BAY SHORE POWER PLANT

INTAKE AND THERMAL DISCHARGE NPDES COMPLIANCE OPTION EVALUATION

Under contract EP-C-05-046, Tetra Tech was tasked by USEPA's Office of Wastewater Management and EPA Region 5 to evaluate data and documentation submitted by FirstEnergy in support of Ohio EPA's ongoing efforts to develop appropriate NPDES permit conditions for FirstEnergy's Bay Shore Power Plant (BSPP) located near Oregon, OH. This effort focuses on impacts that may occur from cooling water withdrawal in the Maumee River estuary and elevated temperature waste discharges to Maumee Bay—two distinct, but related, aspects of the NPDES program.

Figure 4. Thermal Plume—August 21, 2002

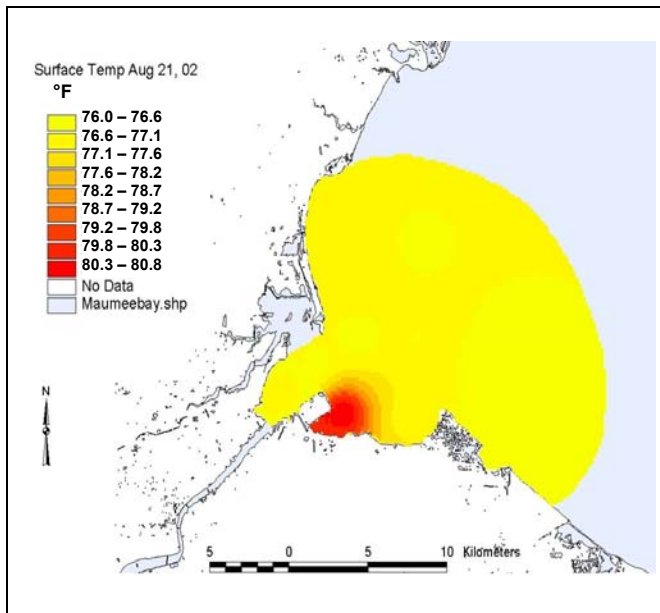
The primary and overriding concern identified in the *2003 Thermal Mixing Zone Study* was how "delta T" was defined and how it was used to delineate the maximum extent of the thermal mixing zone. Generally, delta T refers to the difference between two temperature measurements, but when used to evaluate thermal discharges (and not to determine compliance), the term is defined as the difference between the discharge temperature at some point in the plume and at a point in the receiving water body outside the plume's influence. In this report, delta T was defined as the difference between the appropriate maximum water quality standard for temperature (which varied with date) and the temperature in the discharge or discharge plume.

Using this definition, the thermal mixing zone measured, modeled, and discussed in the 2003 study is the regulatory mixing zone rather than the physical mixing zone. Thus, the thermal plume described in this report is the area within which the temperature exceeds the OEPA temperature criterion and not the area within which the temperature exceeds some measure of background temperature. Because of the way delta T and the thermal plume were defined, the information provided in this report does not describe the areal extent of the thermal plume.

Figure 4 is an example of the facility's thermal plume and its influence on water temperatures relative to background measurements in Maumee Bay for a single day. Data provided by Ohio EPA for this date (August 21, 2002) show that BSPP was discharging wastewater at a rate of 745 mgd and at a temperature

The inability to accurately quantify the thermal mixing zone’s areal extent represents a fundamental deficiency that limits Tetra Tech’s ability to complete the objectives under Task 6 as originally directed. Without a clear understanding of the *physical* mixing zone (rather than one based on compliance standards) any estimate of the mixing zone’s impacts would be incomplete and fail to meet the decision criteria for evaluating alternative thermal effluent limitations (see section 3.1).
